FOR PERCOLATION TESTING AND SITE EVALUATION

RE: Site Inspection
14356 Dorsey Mill Road

OWNER/DEVELOPER: JAMES AND CHRISTINA SELFRIDGE 14045 GARED DRIVE GLENWOOD, MD 21738 410-531-8930	PROJECT: 14356 DORSEY MILL ROAD
	LOCATION: TAX MAP: 21, GRID: 17 FORTH ELECTION DISTRICT HOWARD COUNTY, MARYLAND
	TITLE: PERCOLATION TESTING PLAN
DATE: FEBRUARY, 2006	PROJECT NO. 1893
DES: JC	DRAFT: JC
CHECK: DAM	SCALE: 1" = 50'
	SHEET 1 OF 1

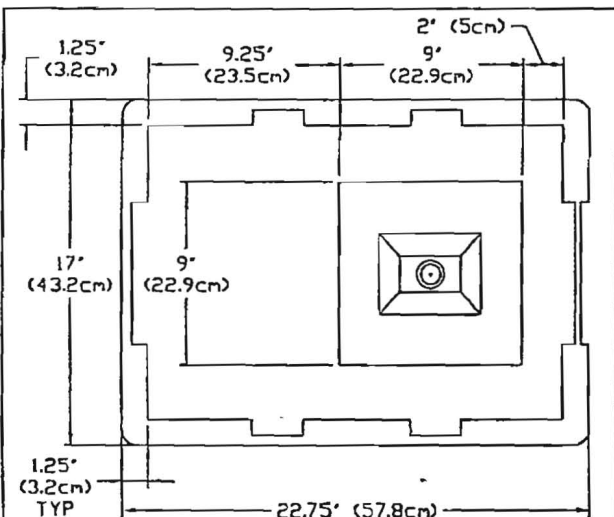
Per my site inspection, topography is very gentle, especially on the west side of the property. The eastern side is a couple of feet higher but on a gentle slope. Locations of the surrounding wells do not appear to be compromised due to the slope.

Review of the percolation test notes for this and surrounding properties show percolation test rates and soils homogenous. Brian Baker's soil description of rock 25-30% summarize 10 feet of depth. Past percolation test notes indicate deep tests around 10' at 9-11 minutes. According to Bob Sheesley, prior to the review of the percolation test notes, the subdivision across the street had no rock issues and profiles contained sandy loam. It appears the subdivision across the street has similar soils to the above mentioned address and surrounding lots.

I would recommend approval of the site plan as is with a septic design specifying septic invert at 2' and bottom at 8-9'. This would allow for optimal oxygen infusion/diffusion from the air into the trench stone. Also, the deeper trench design would support the most efficiency maintaining setbacks to any surrounding well radii on the backyard lots (Sharp Road). *Pre-App.*
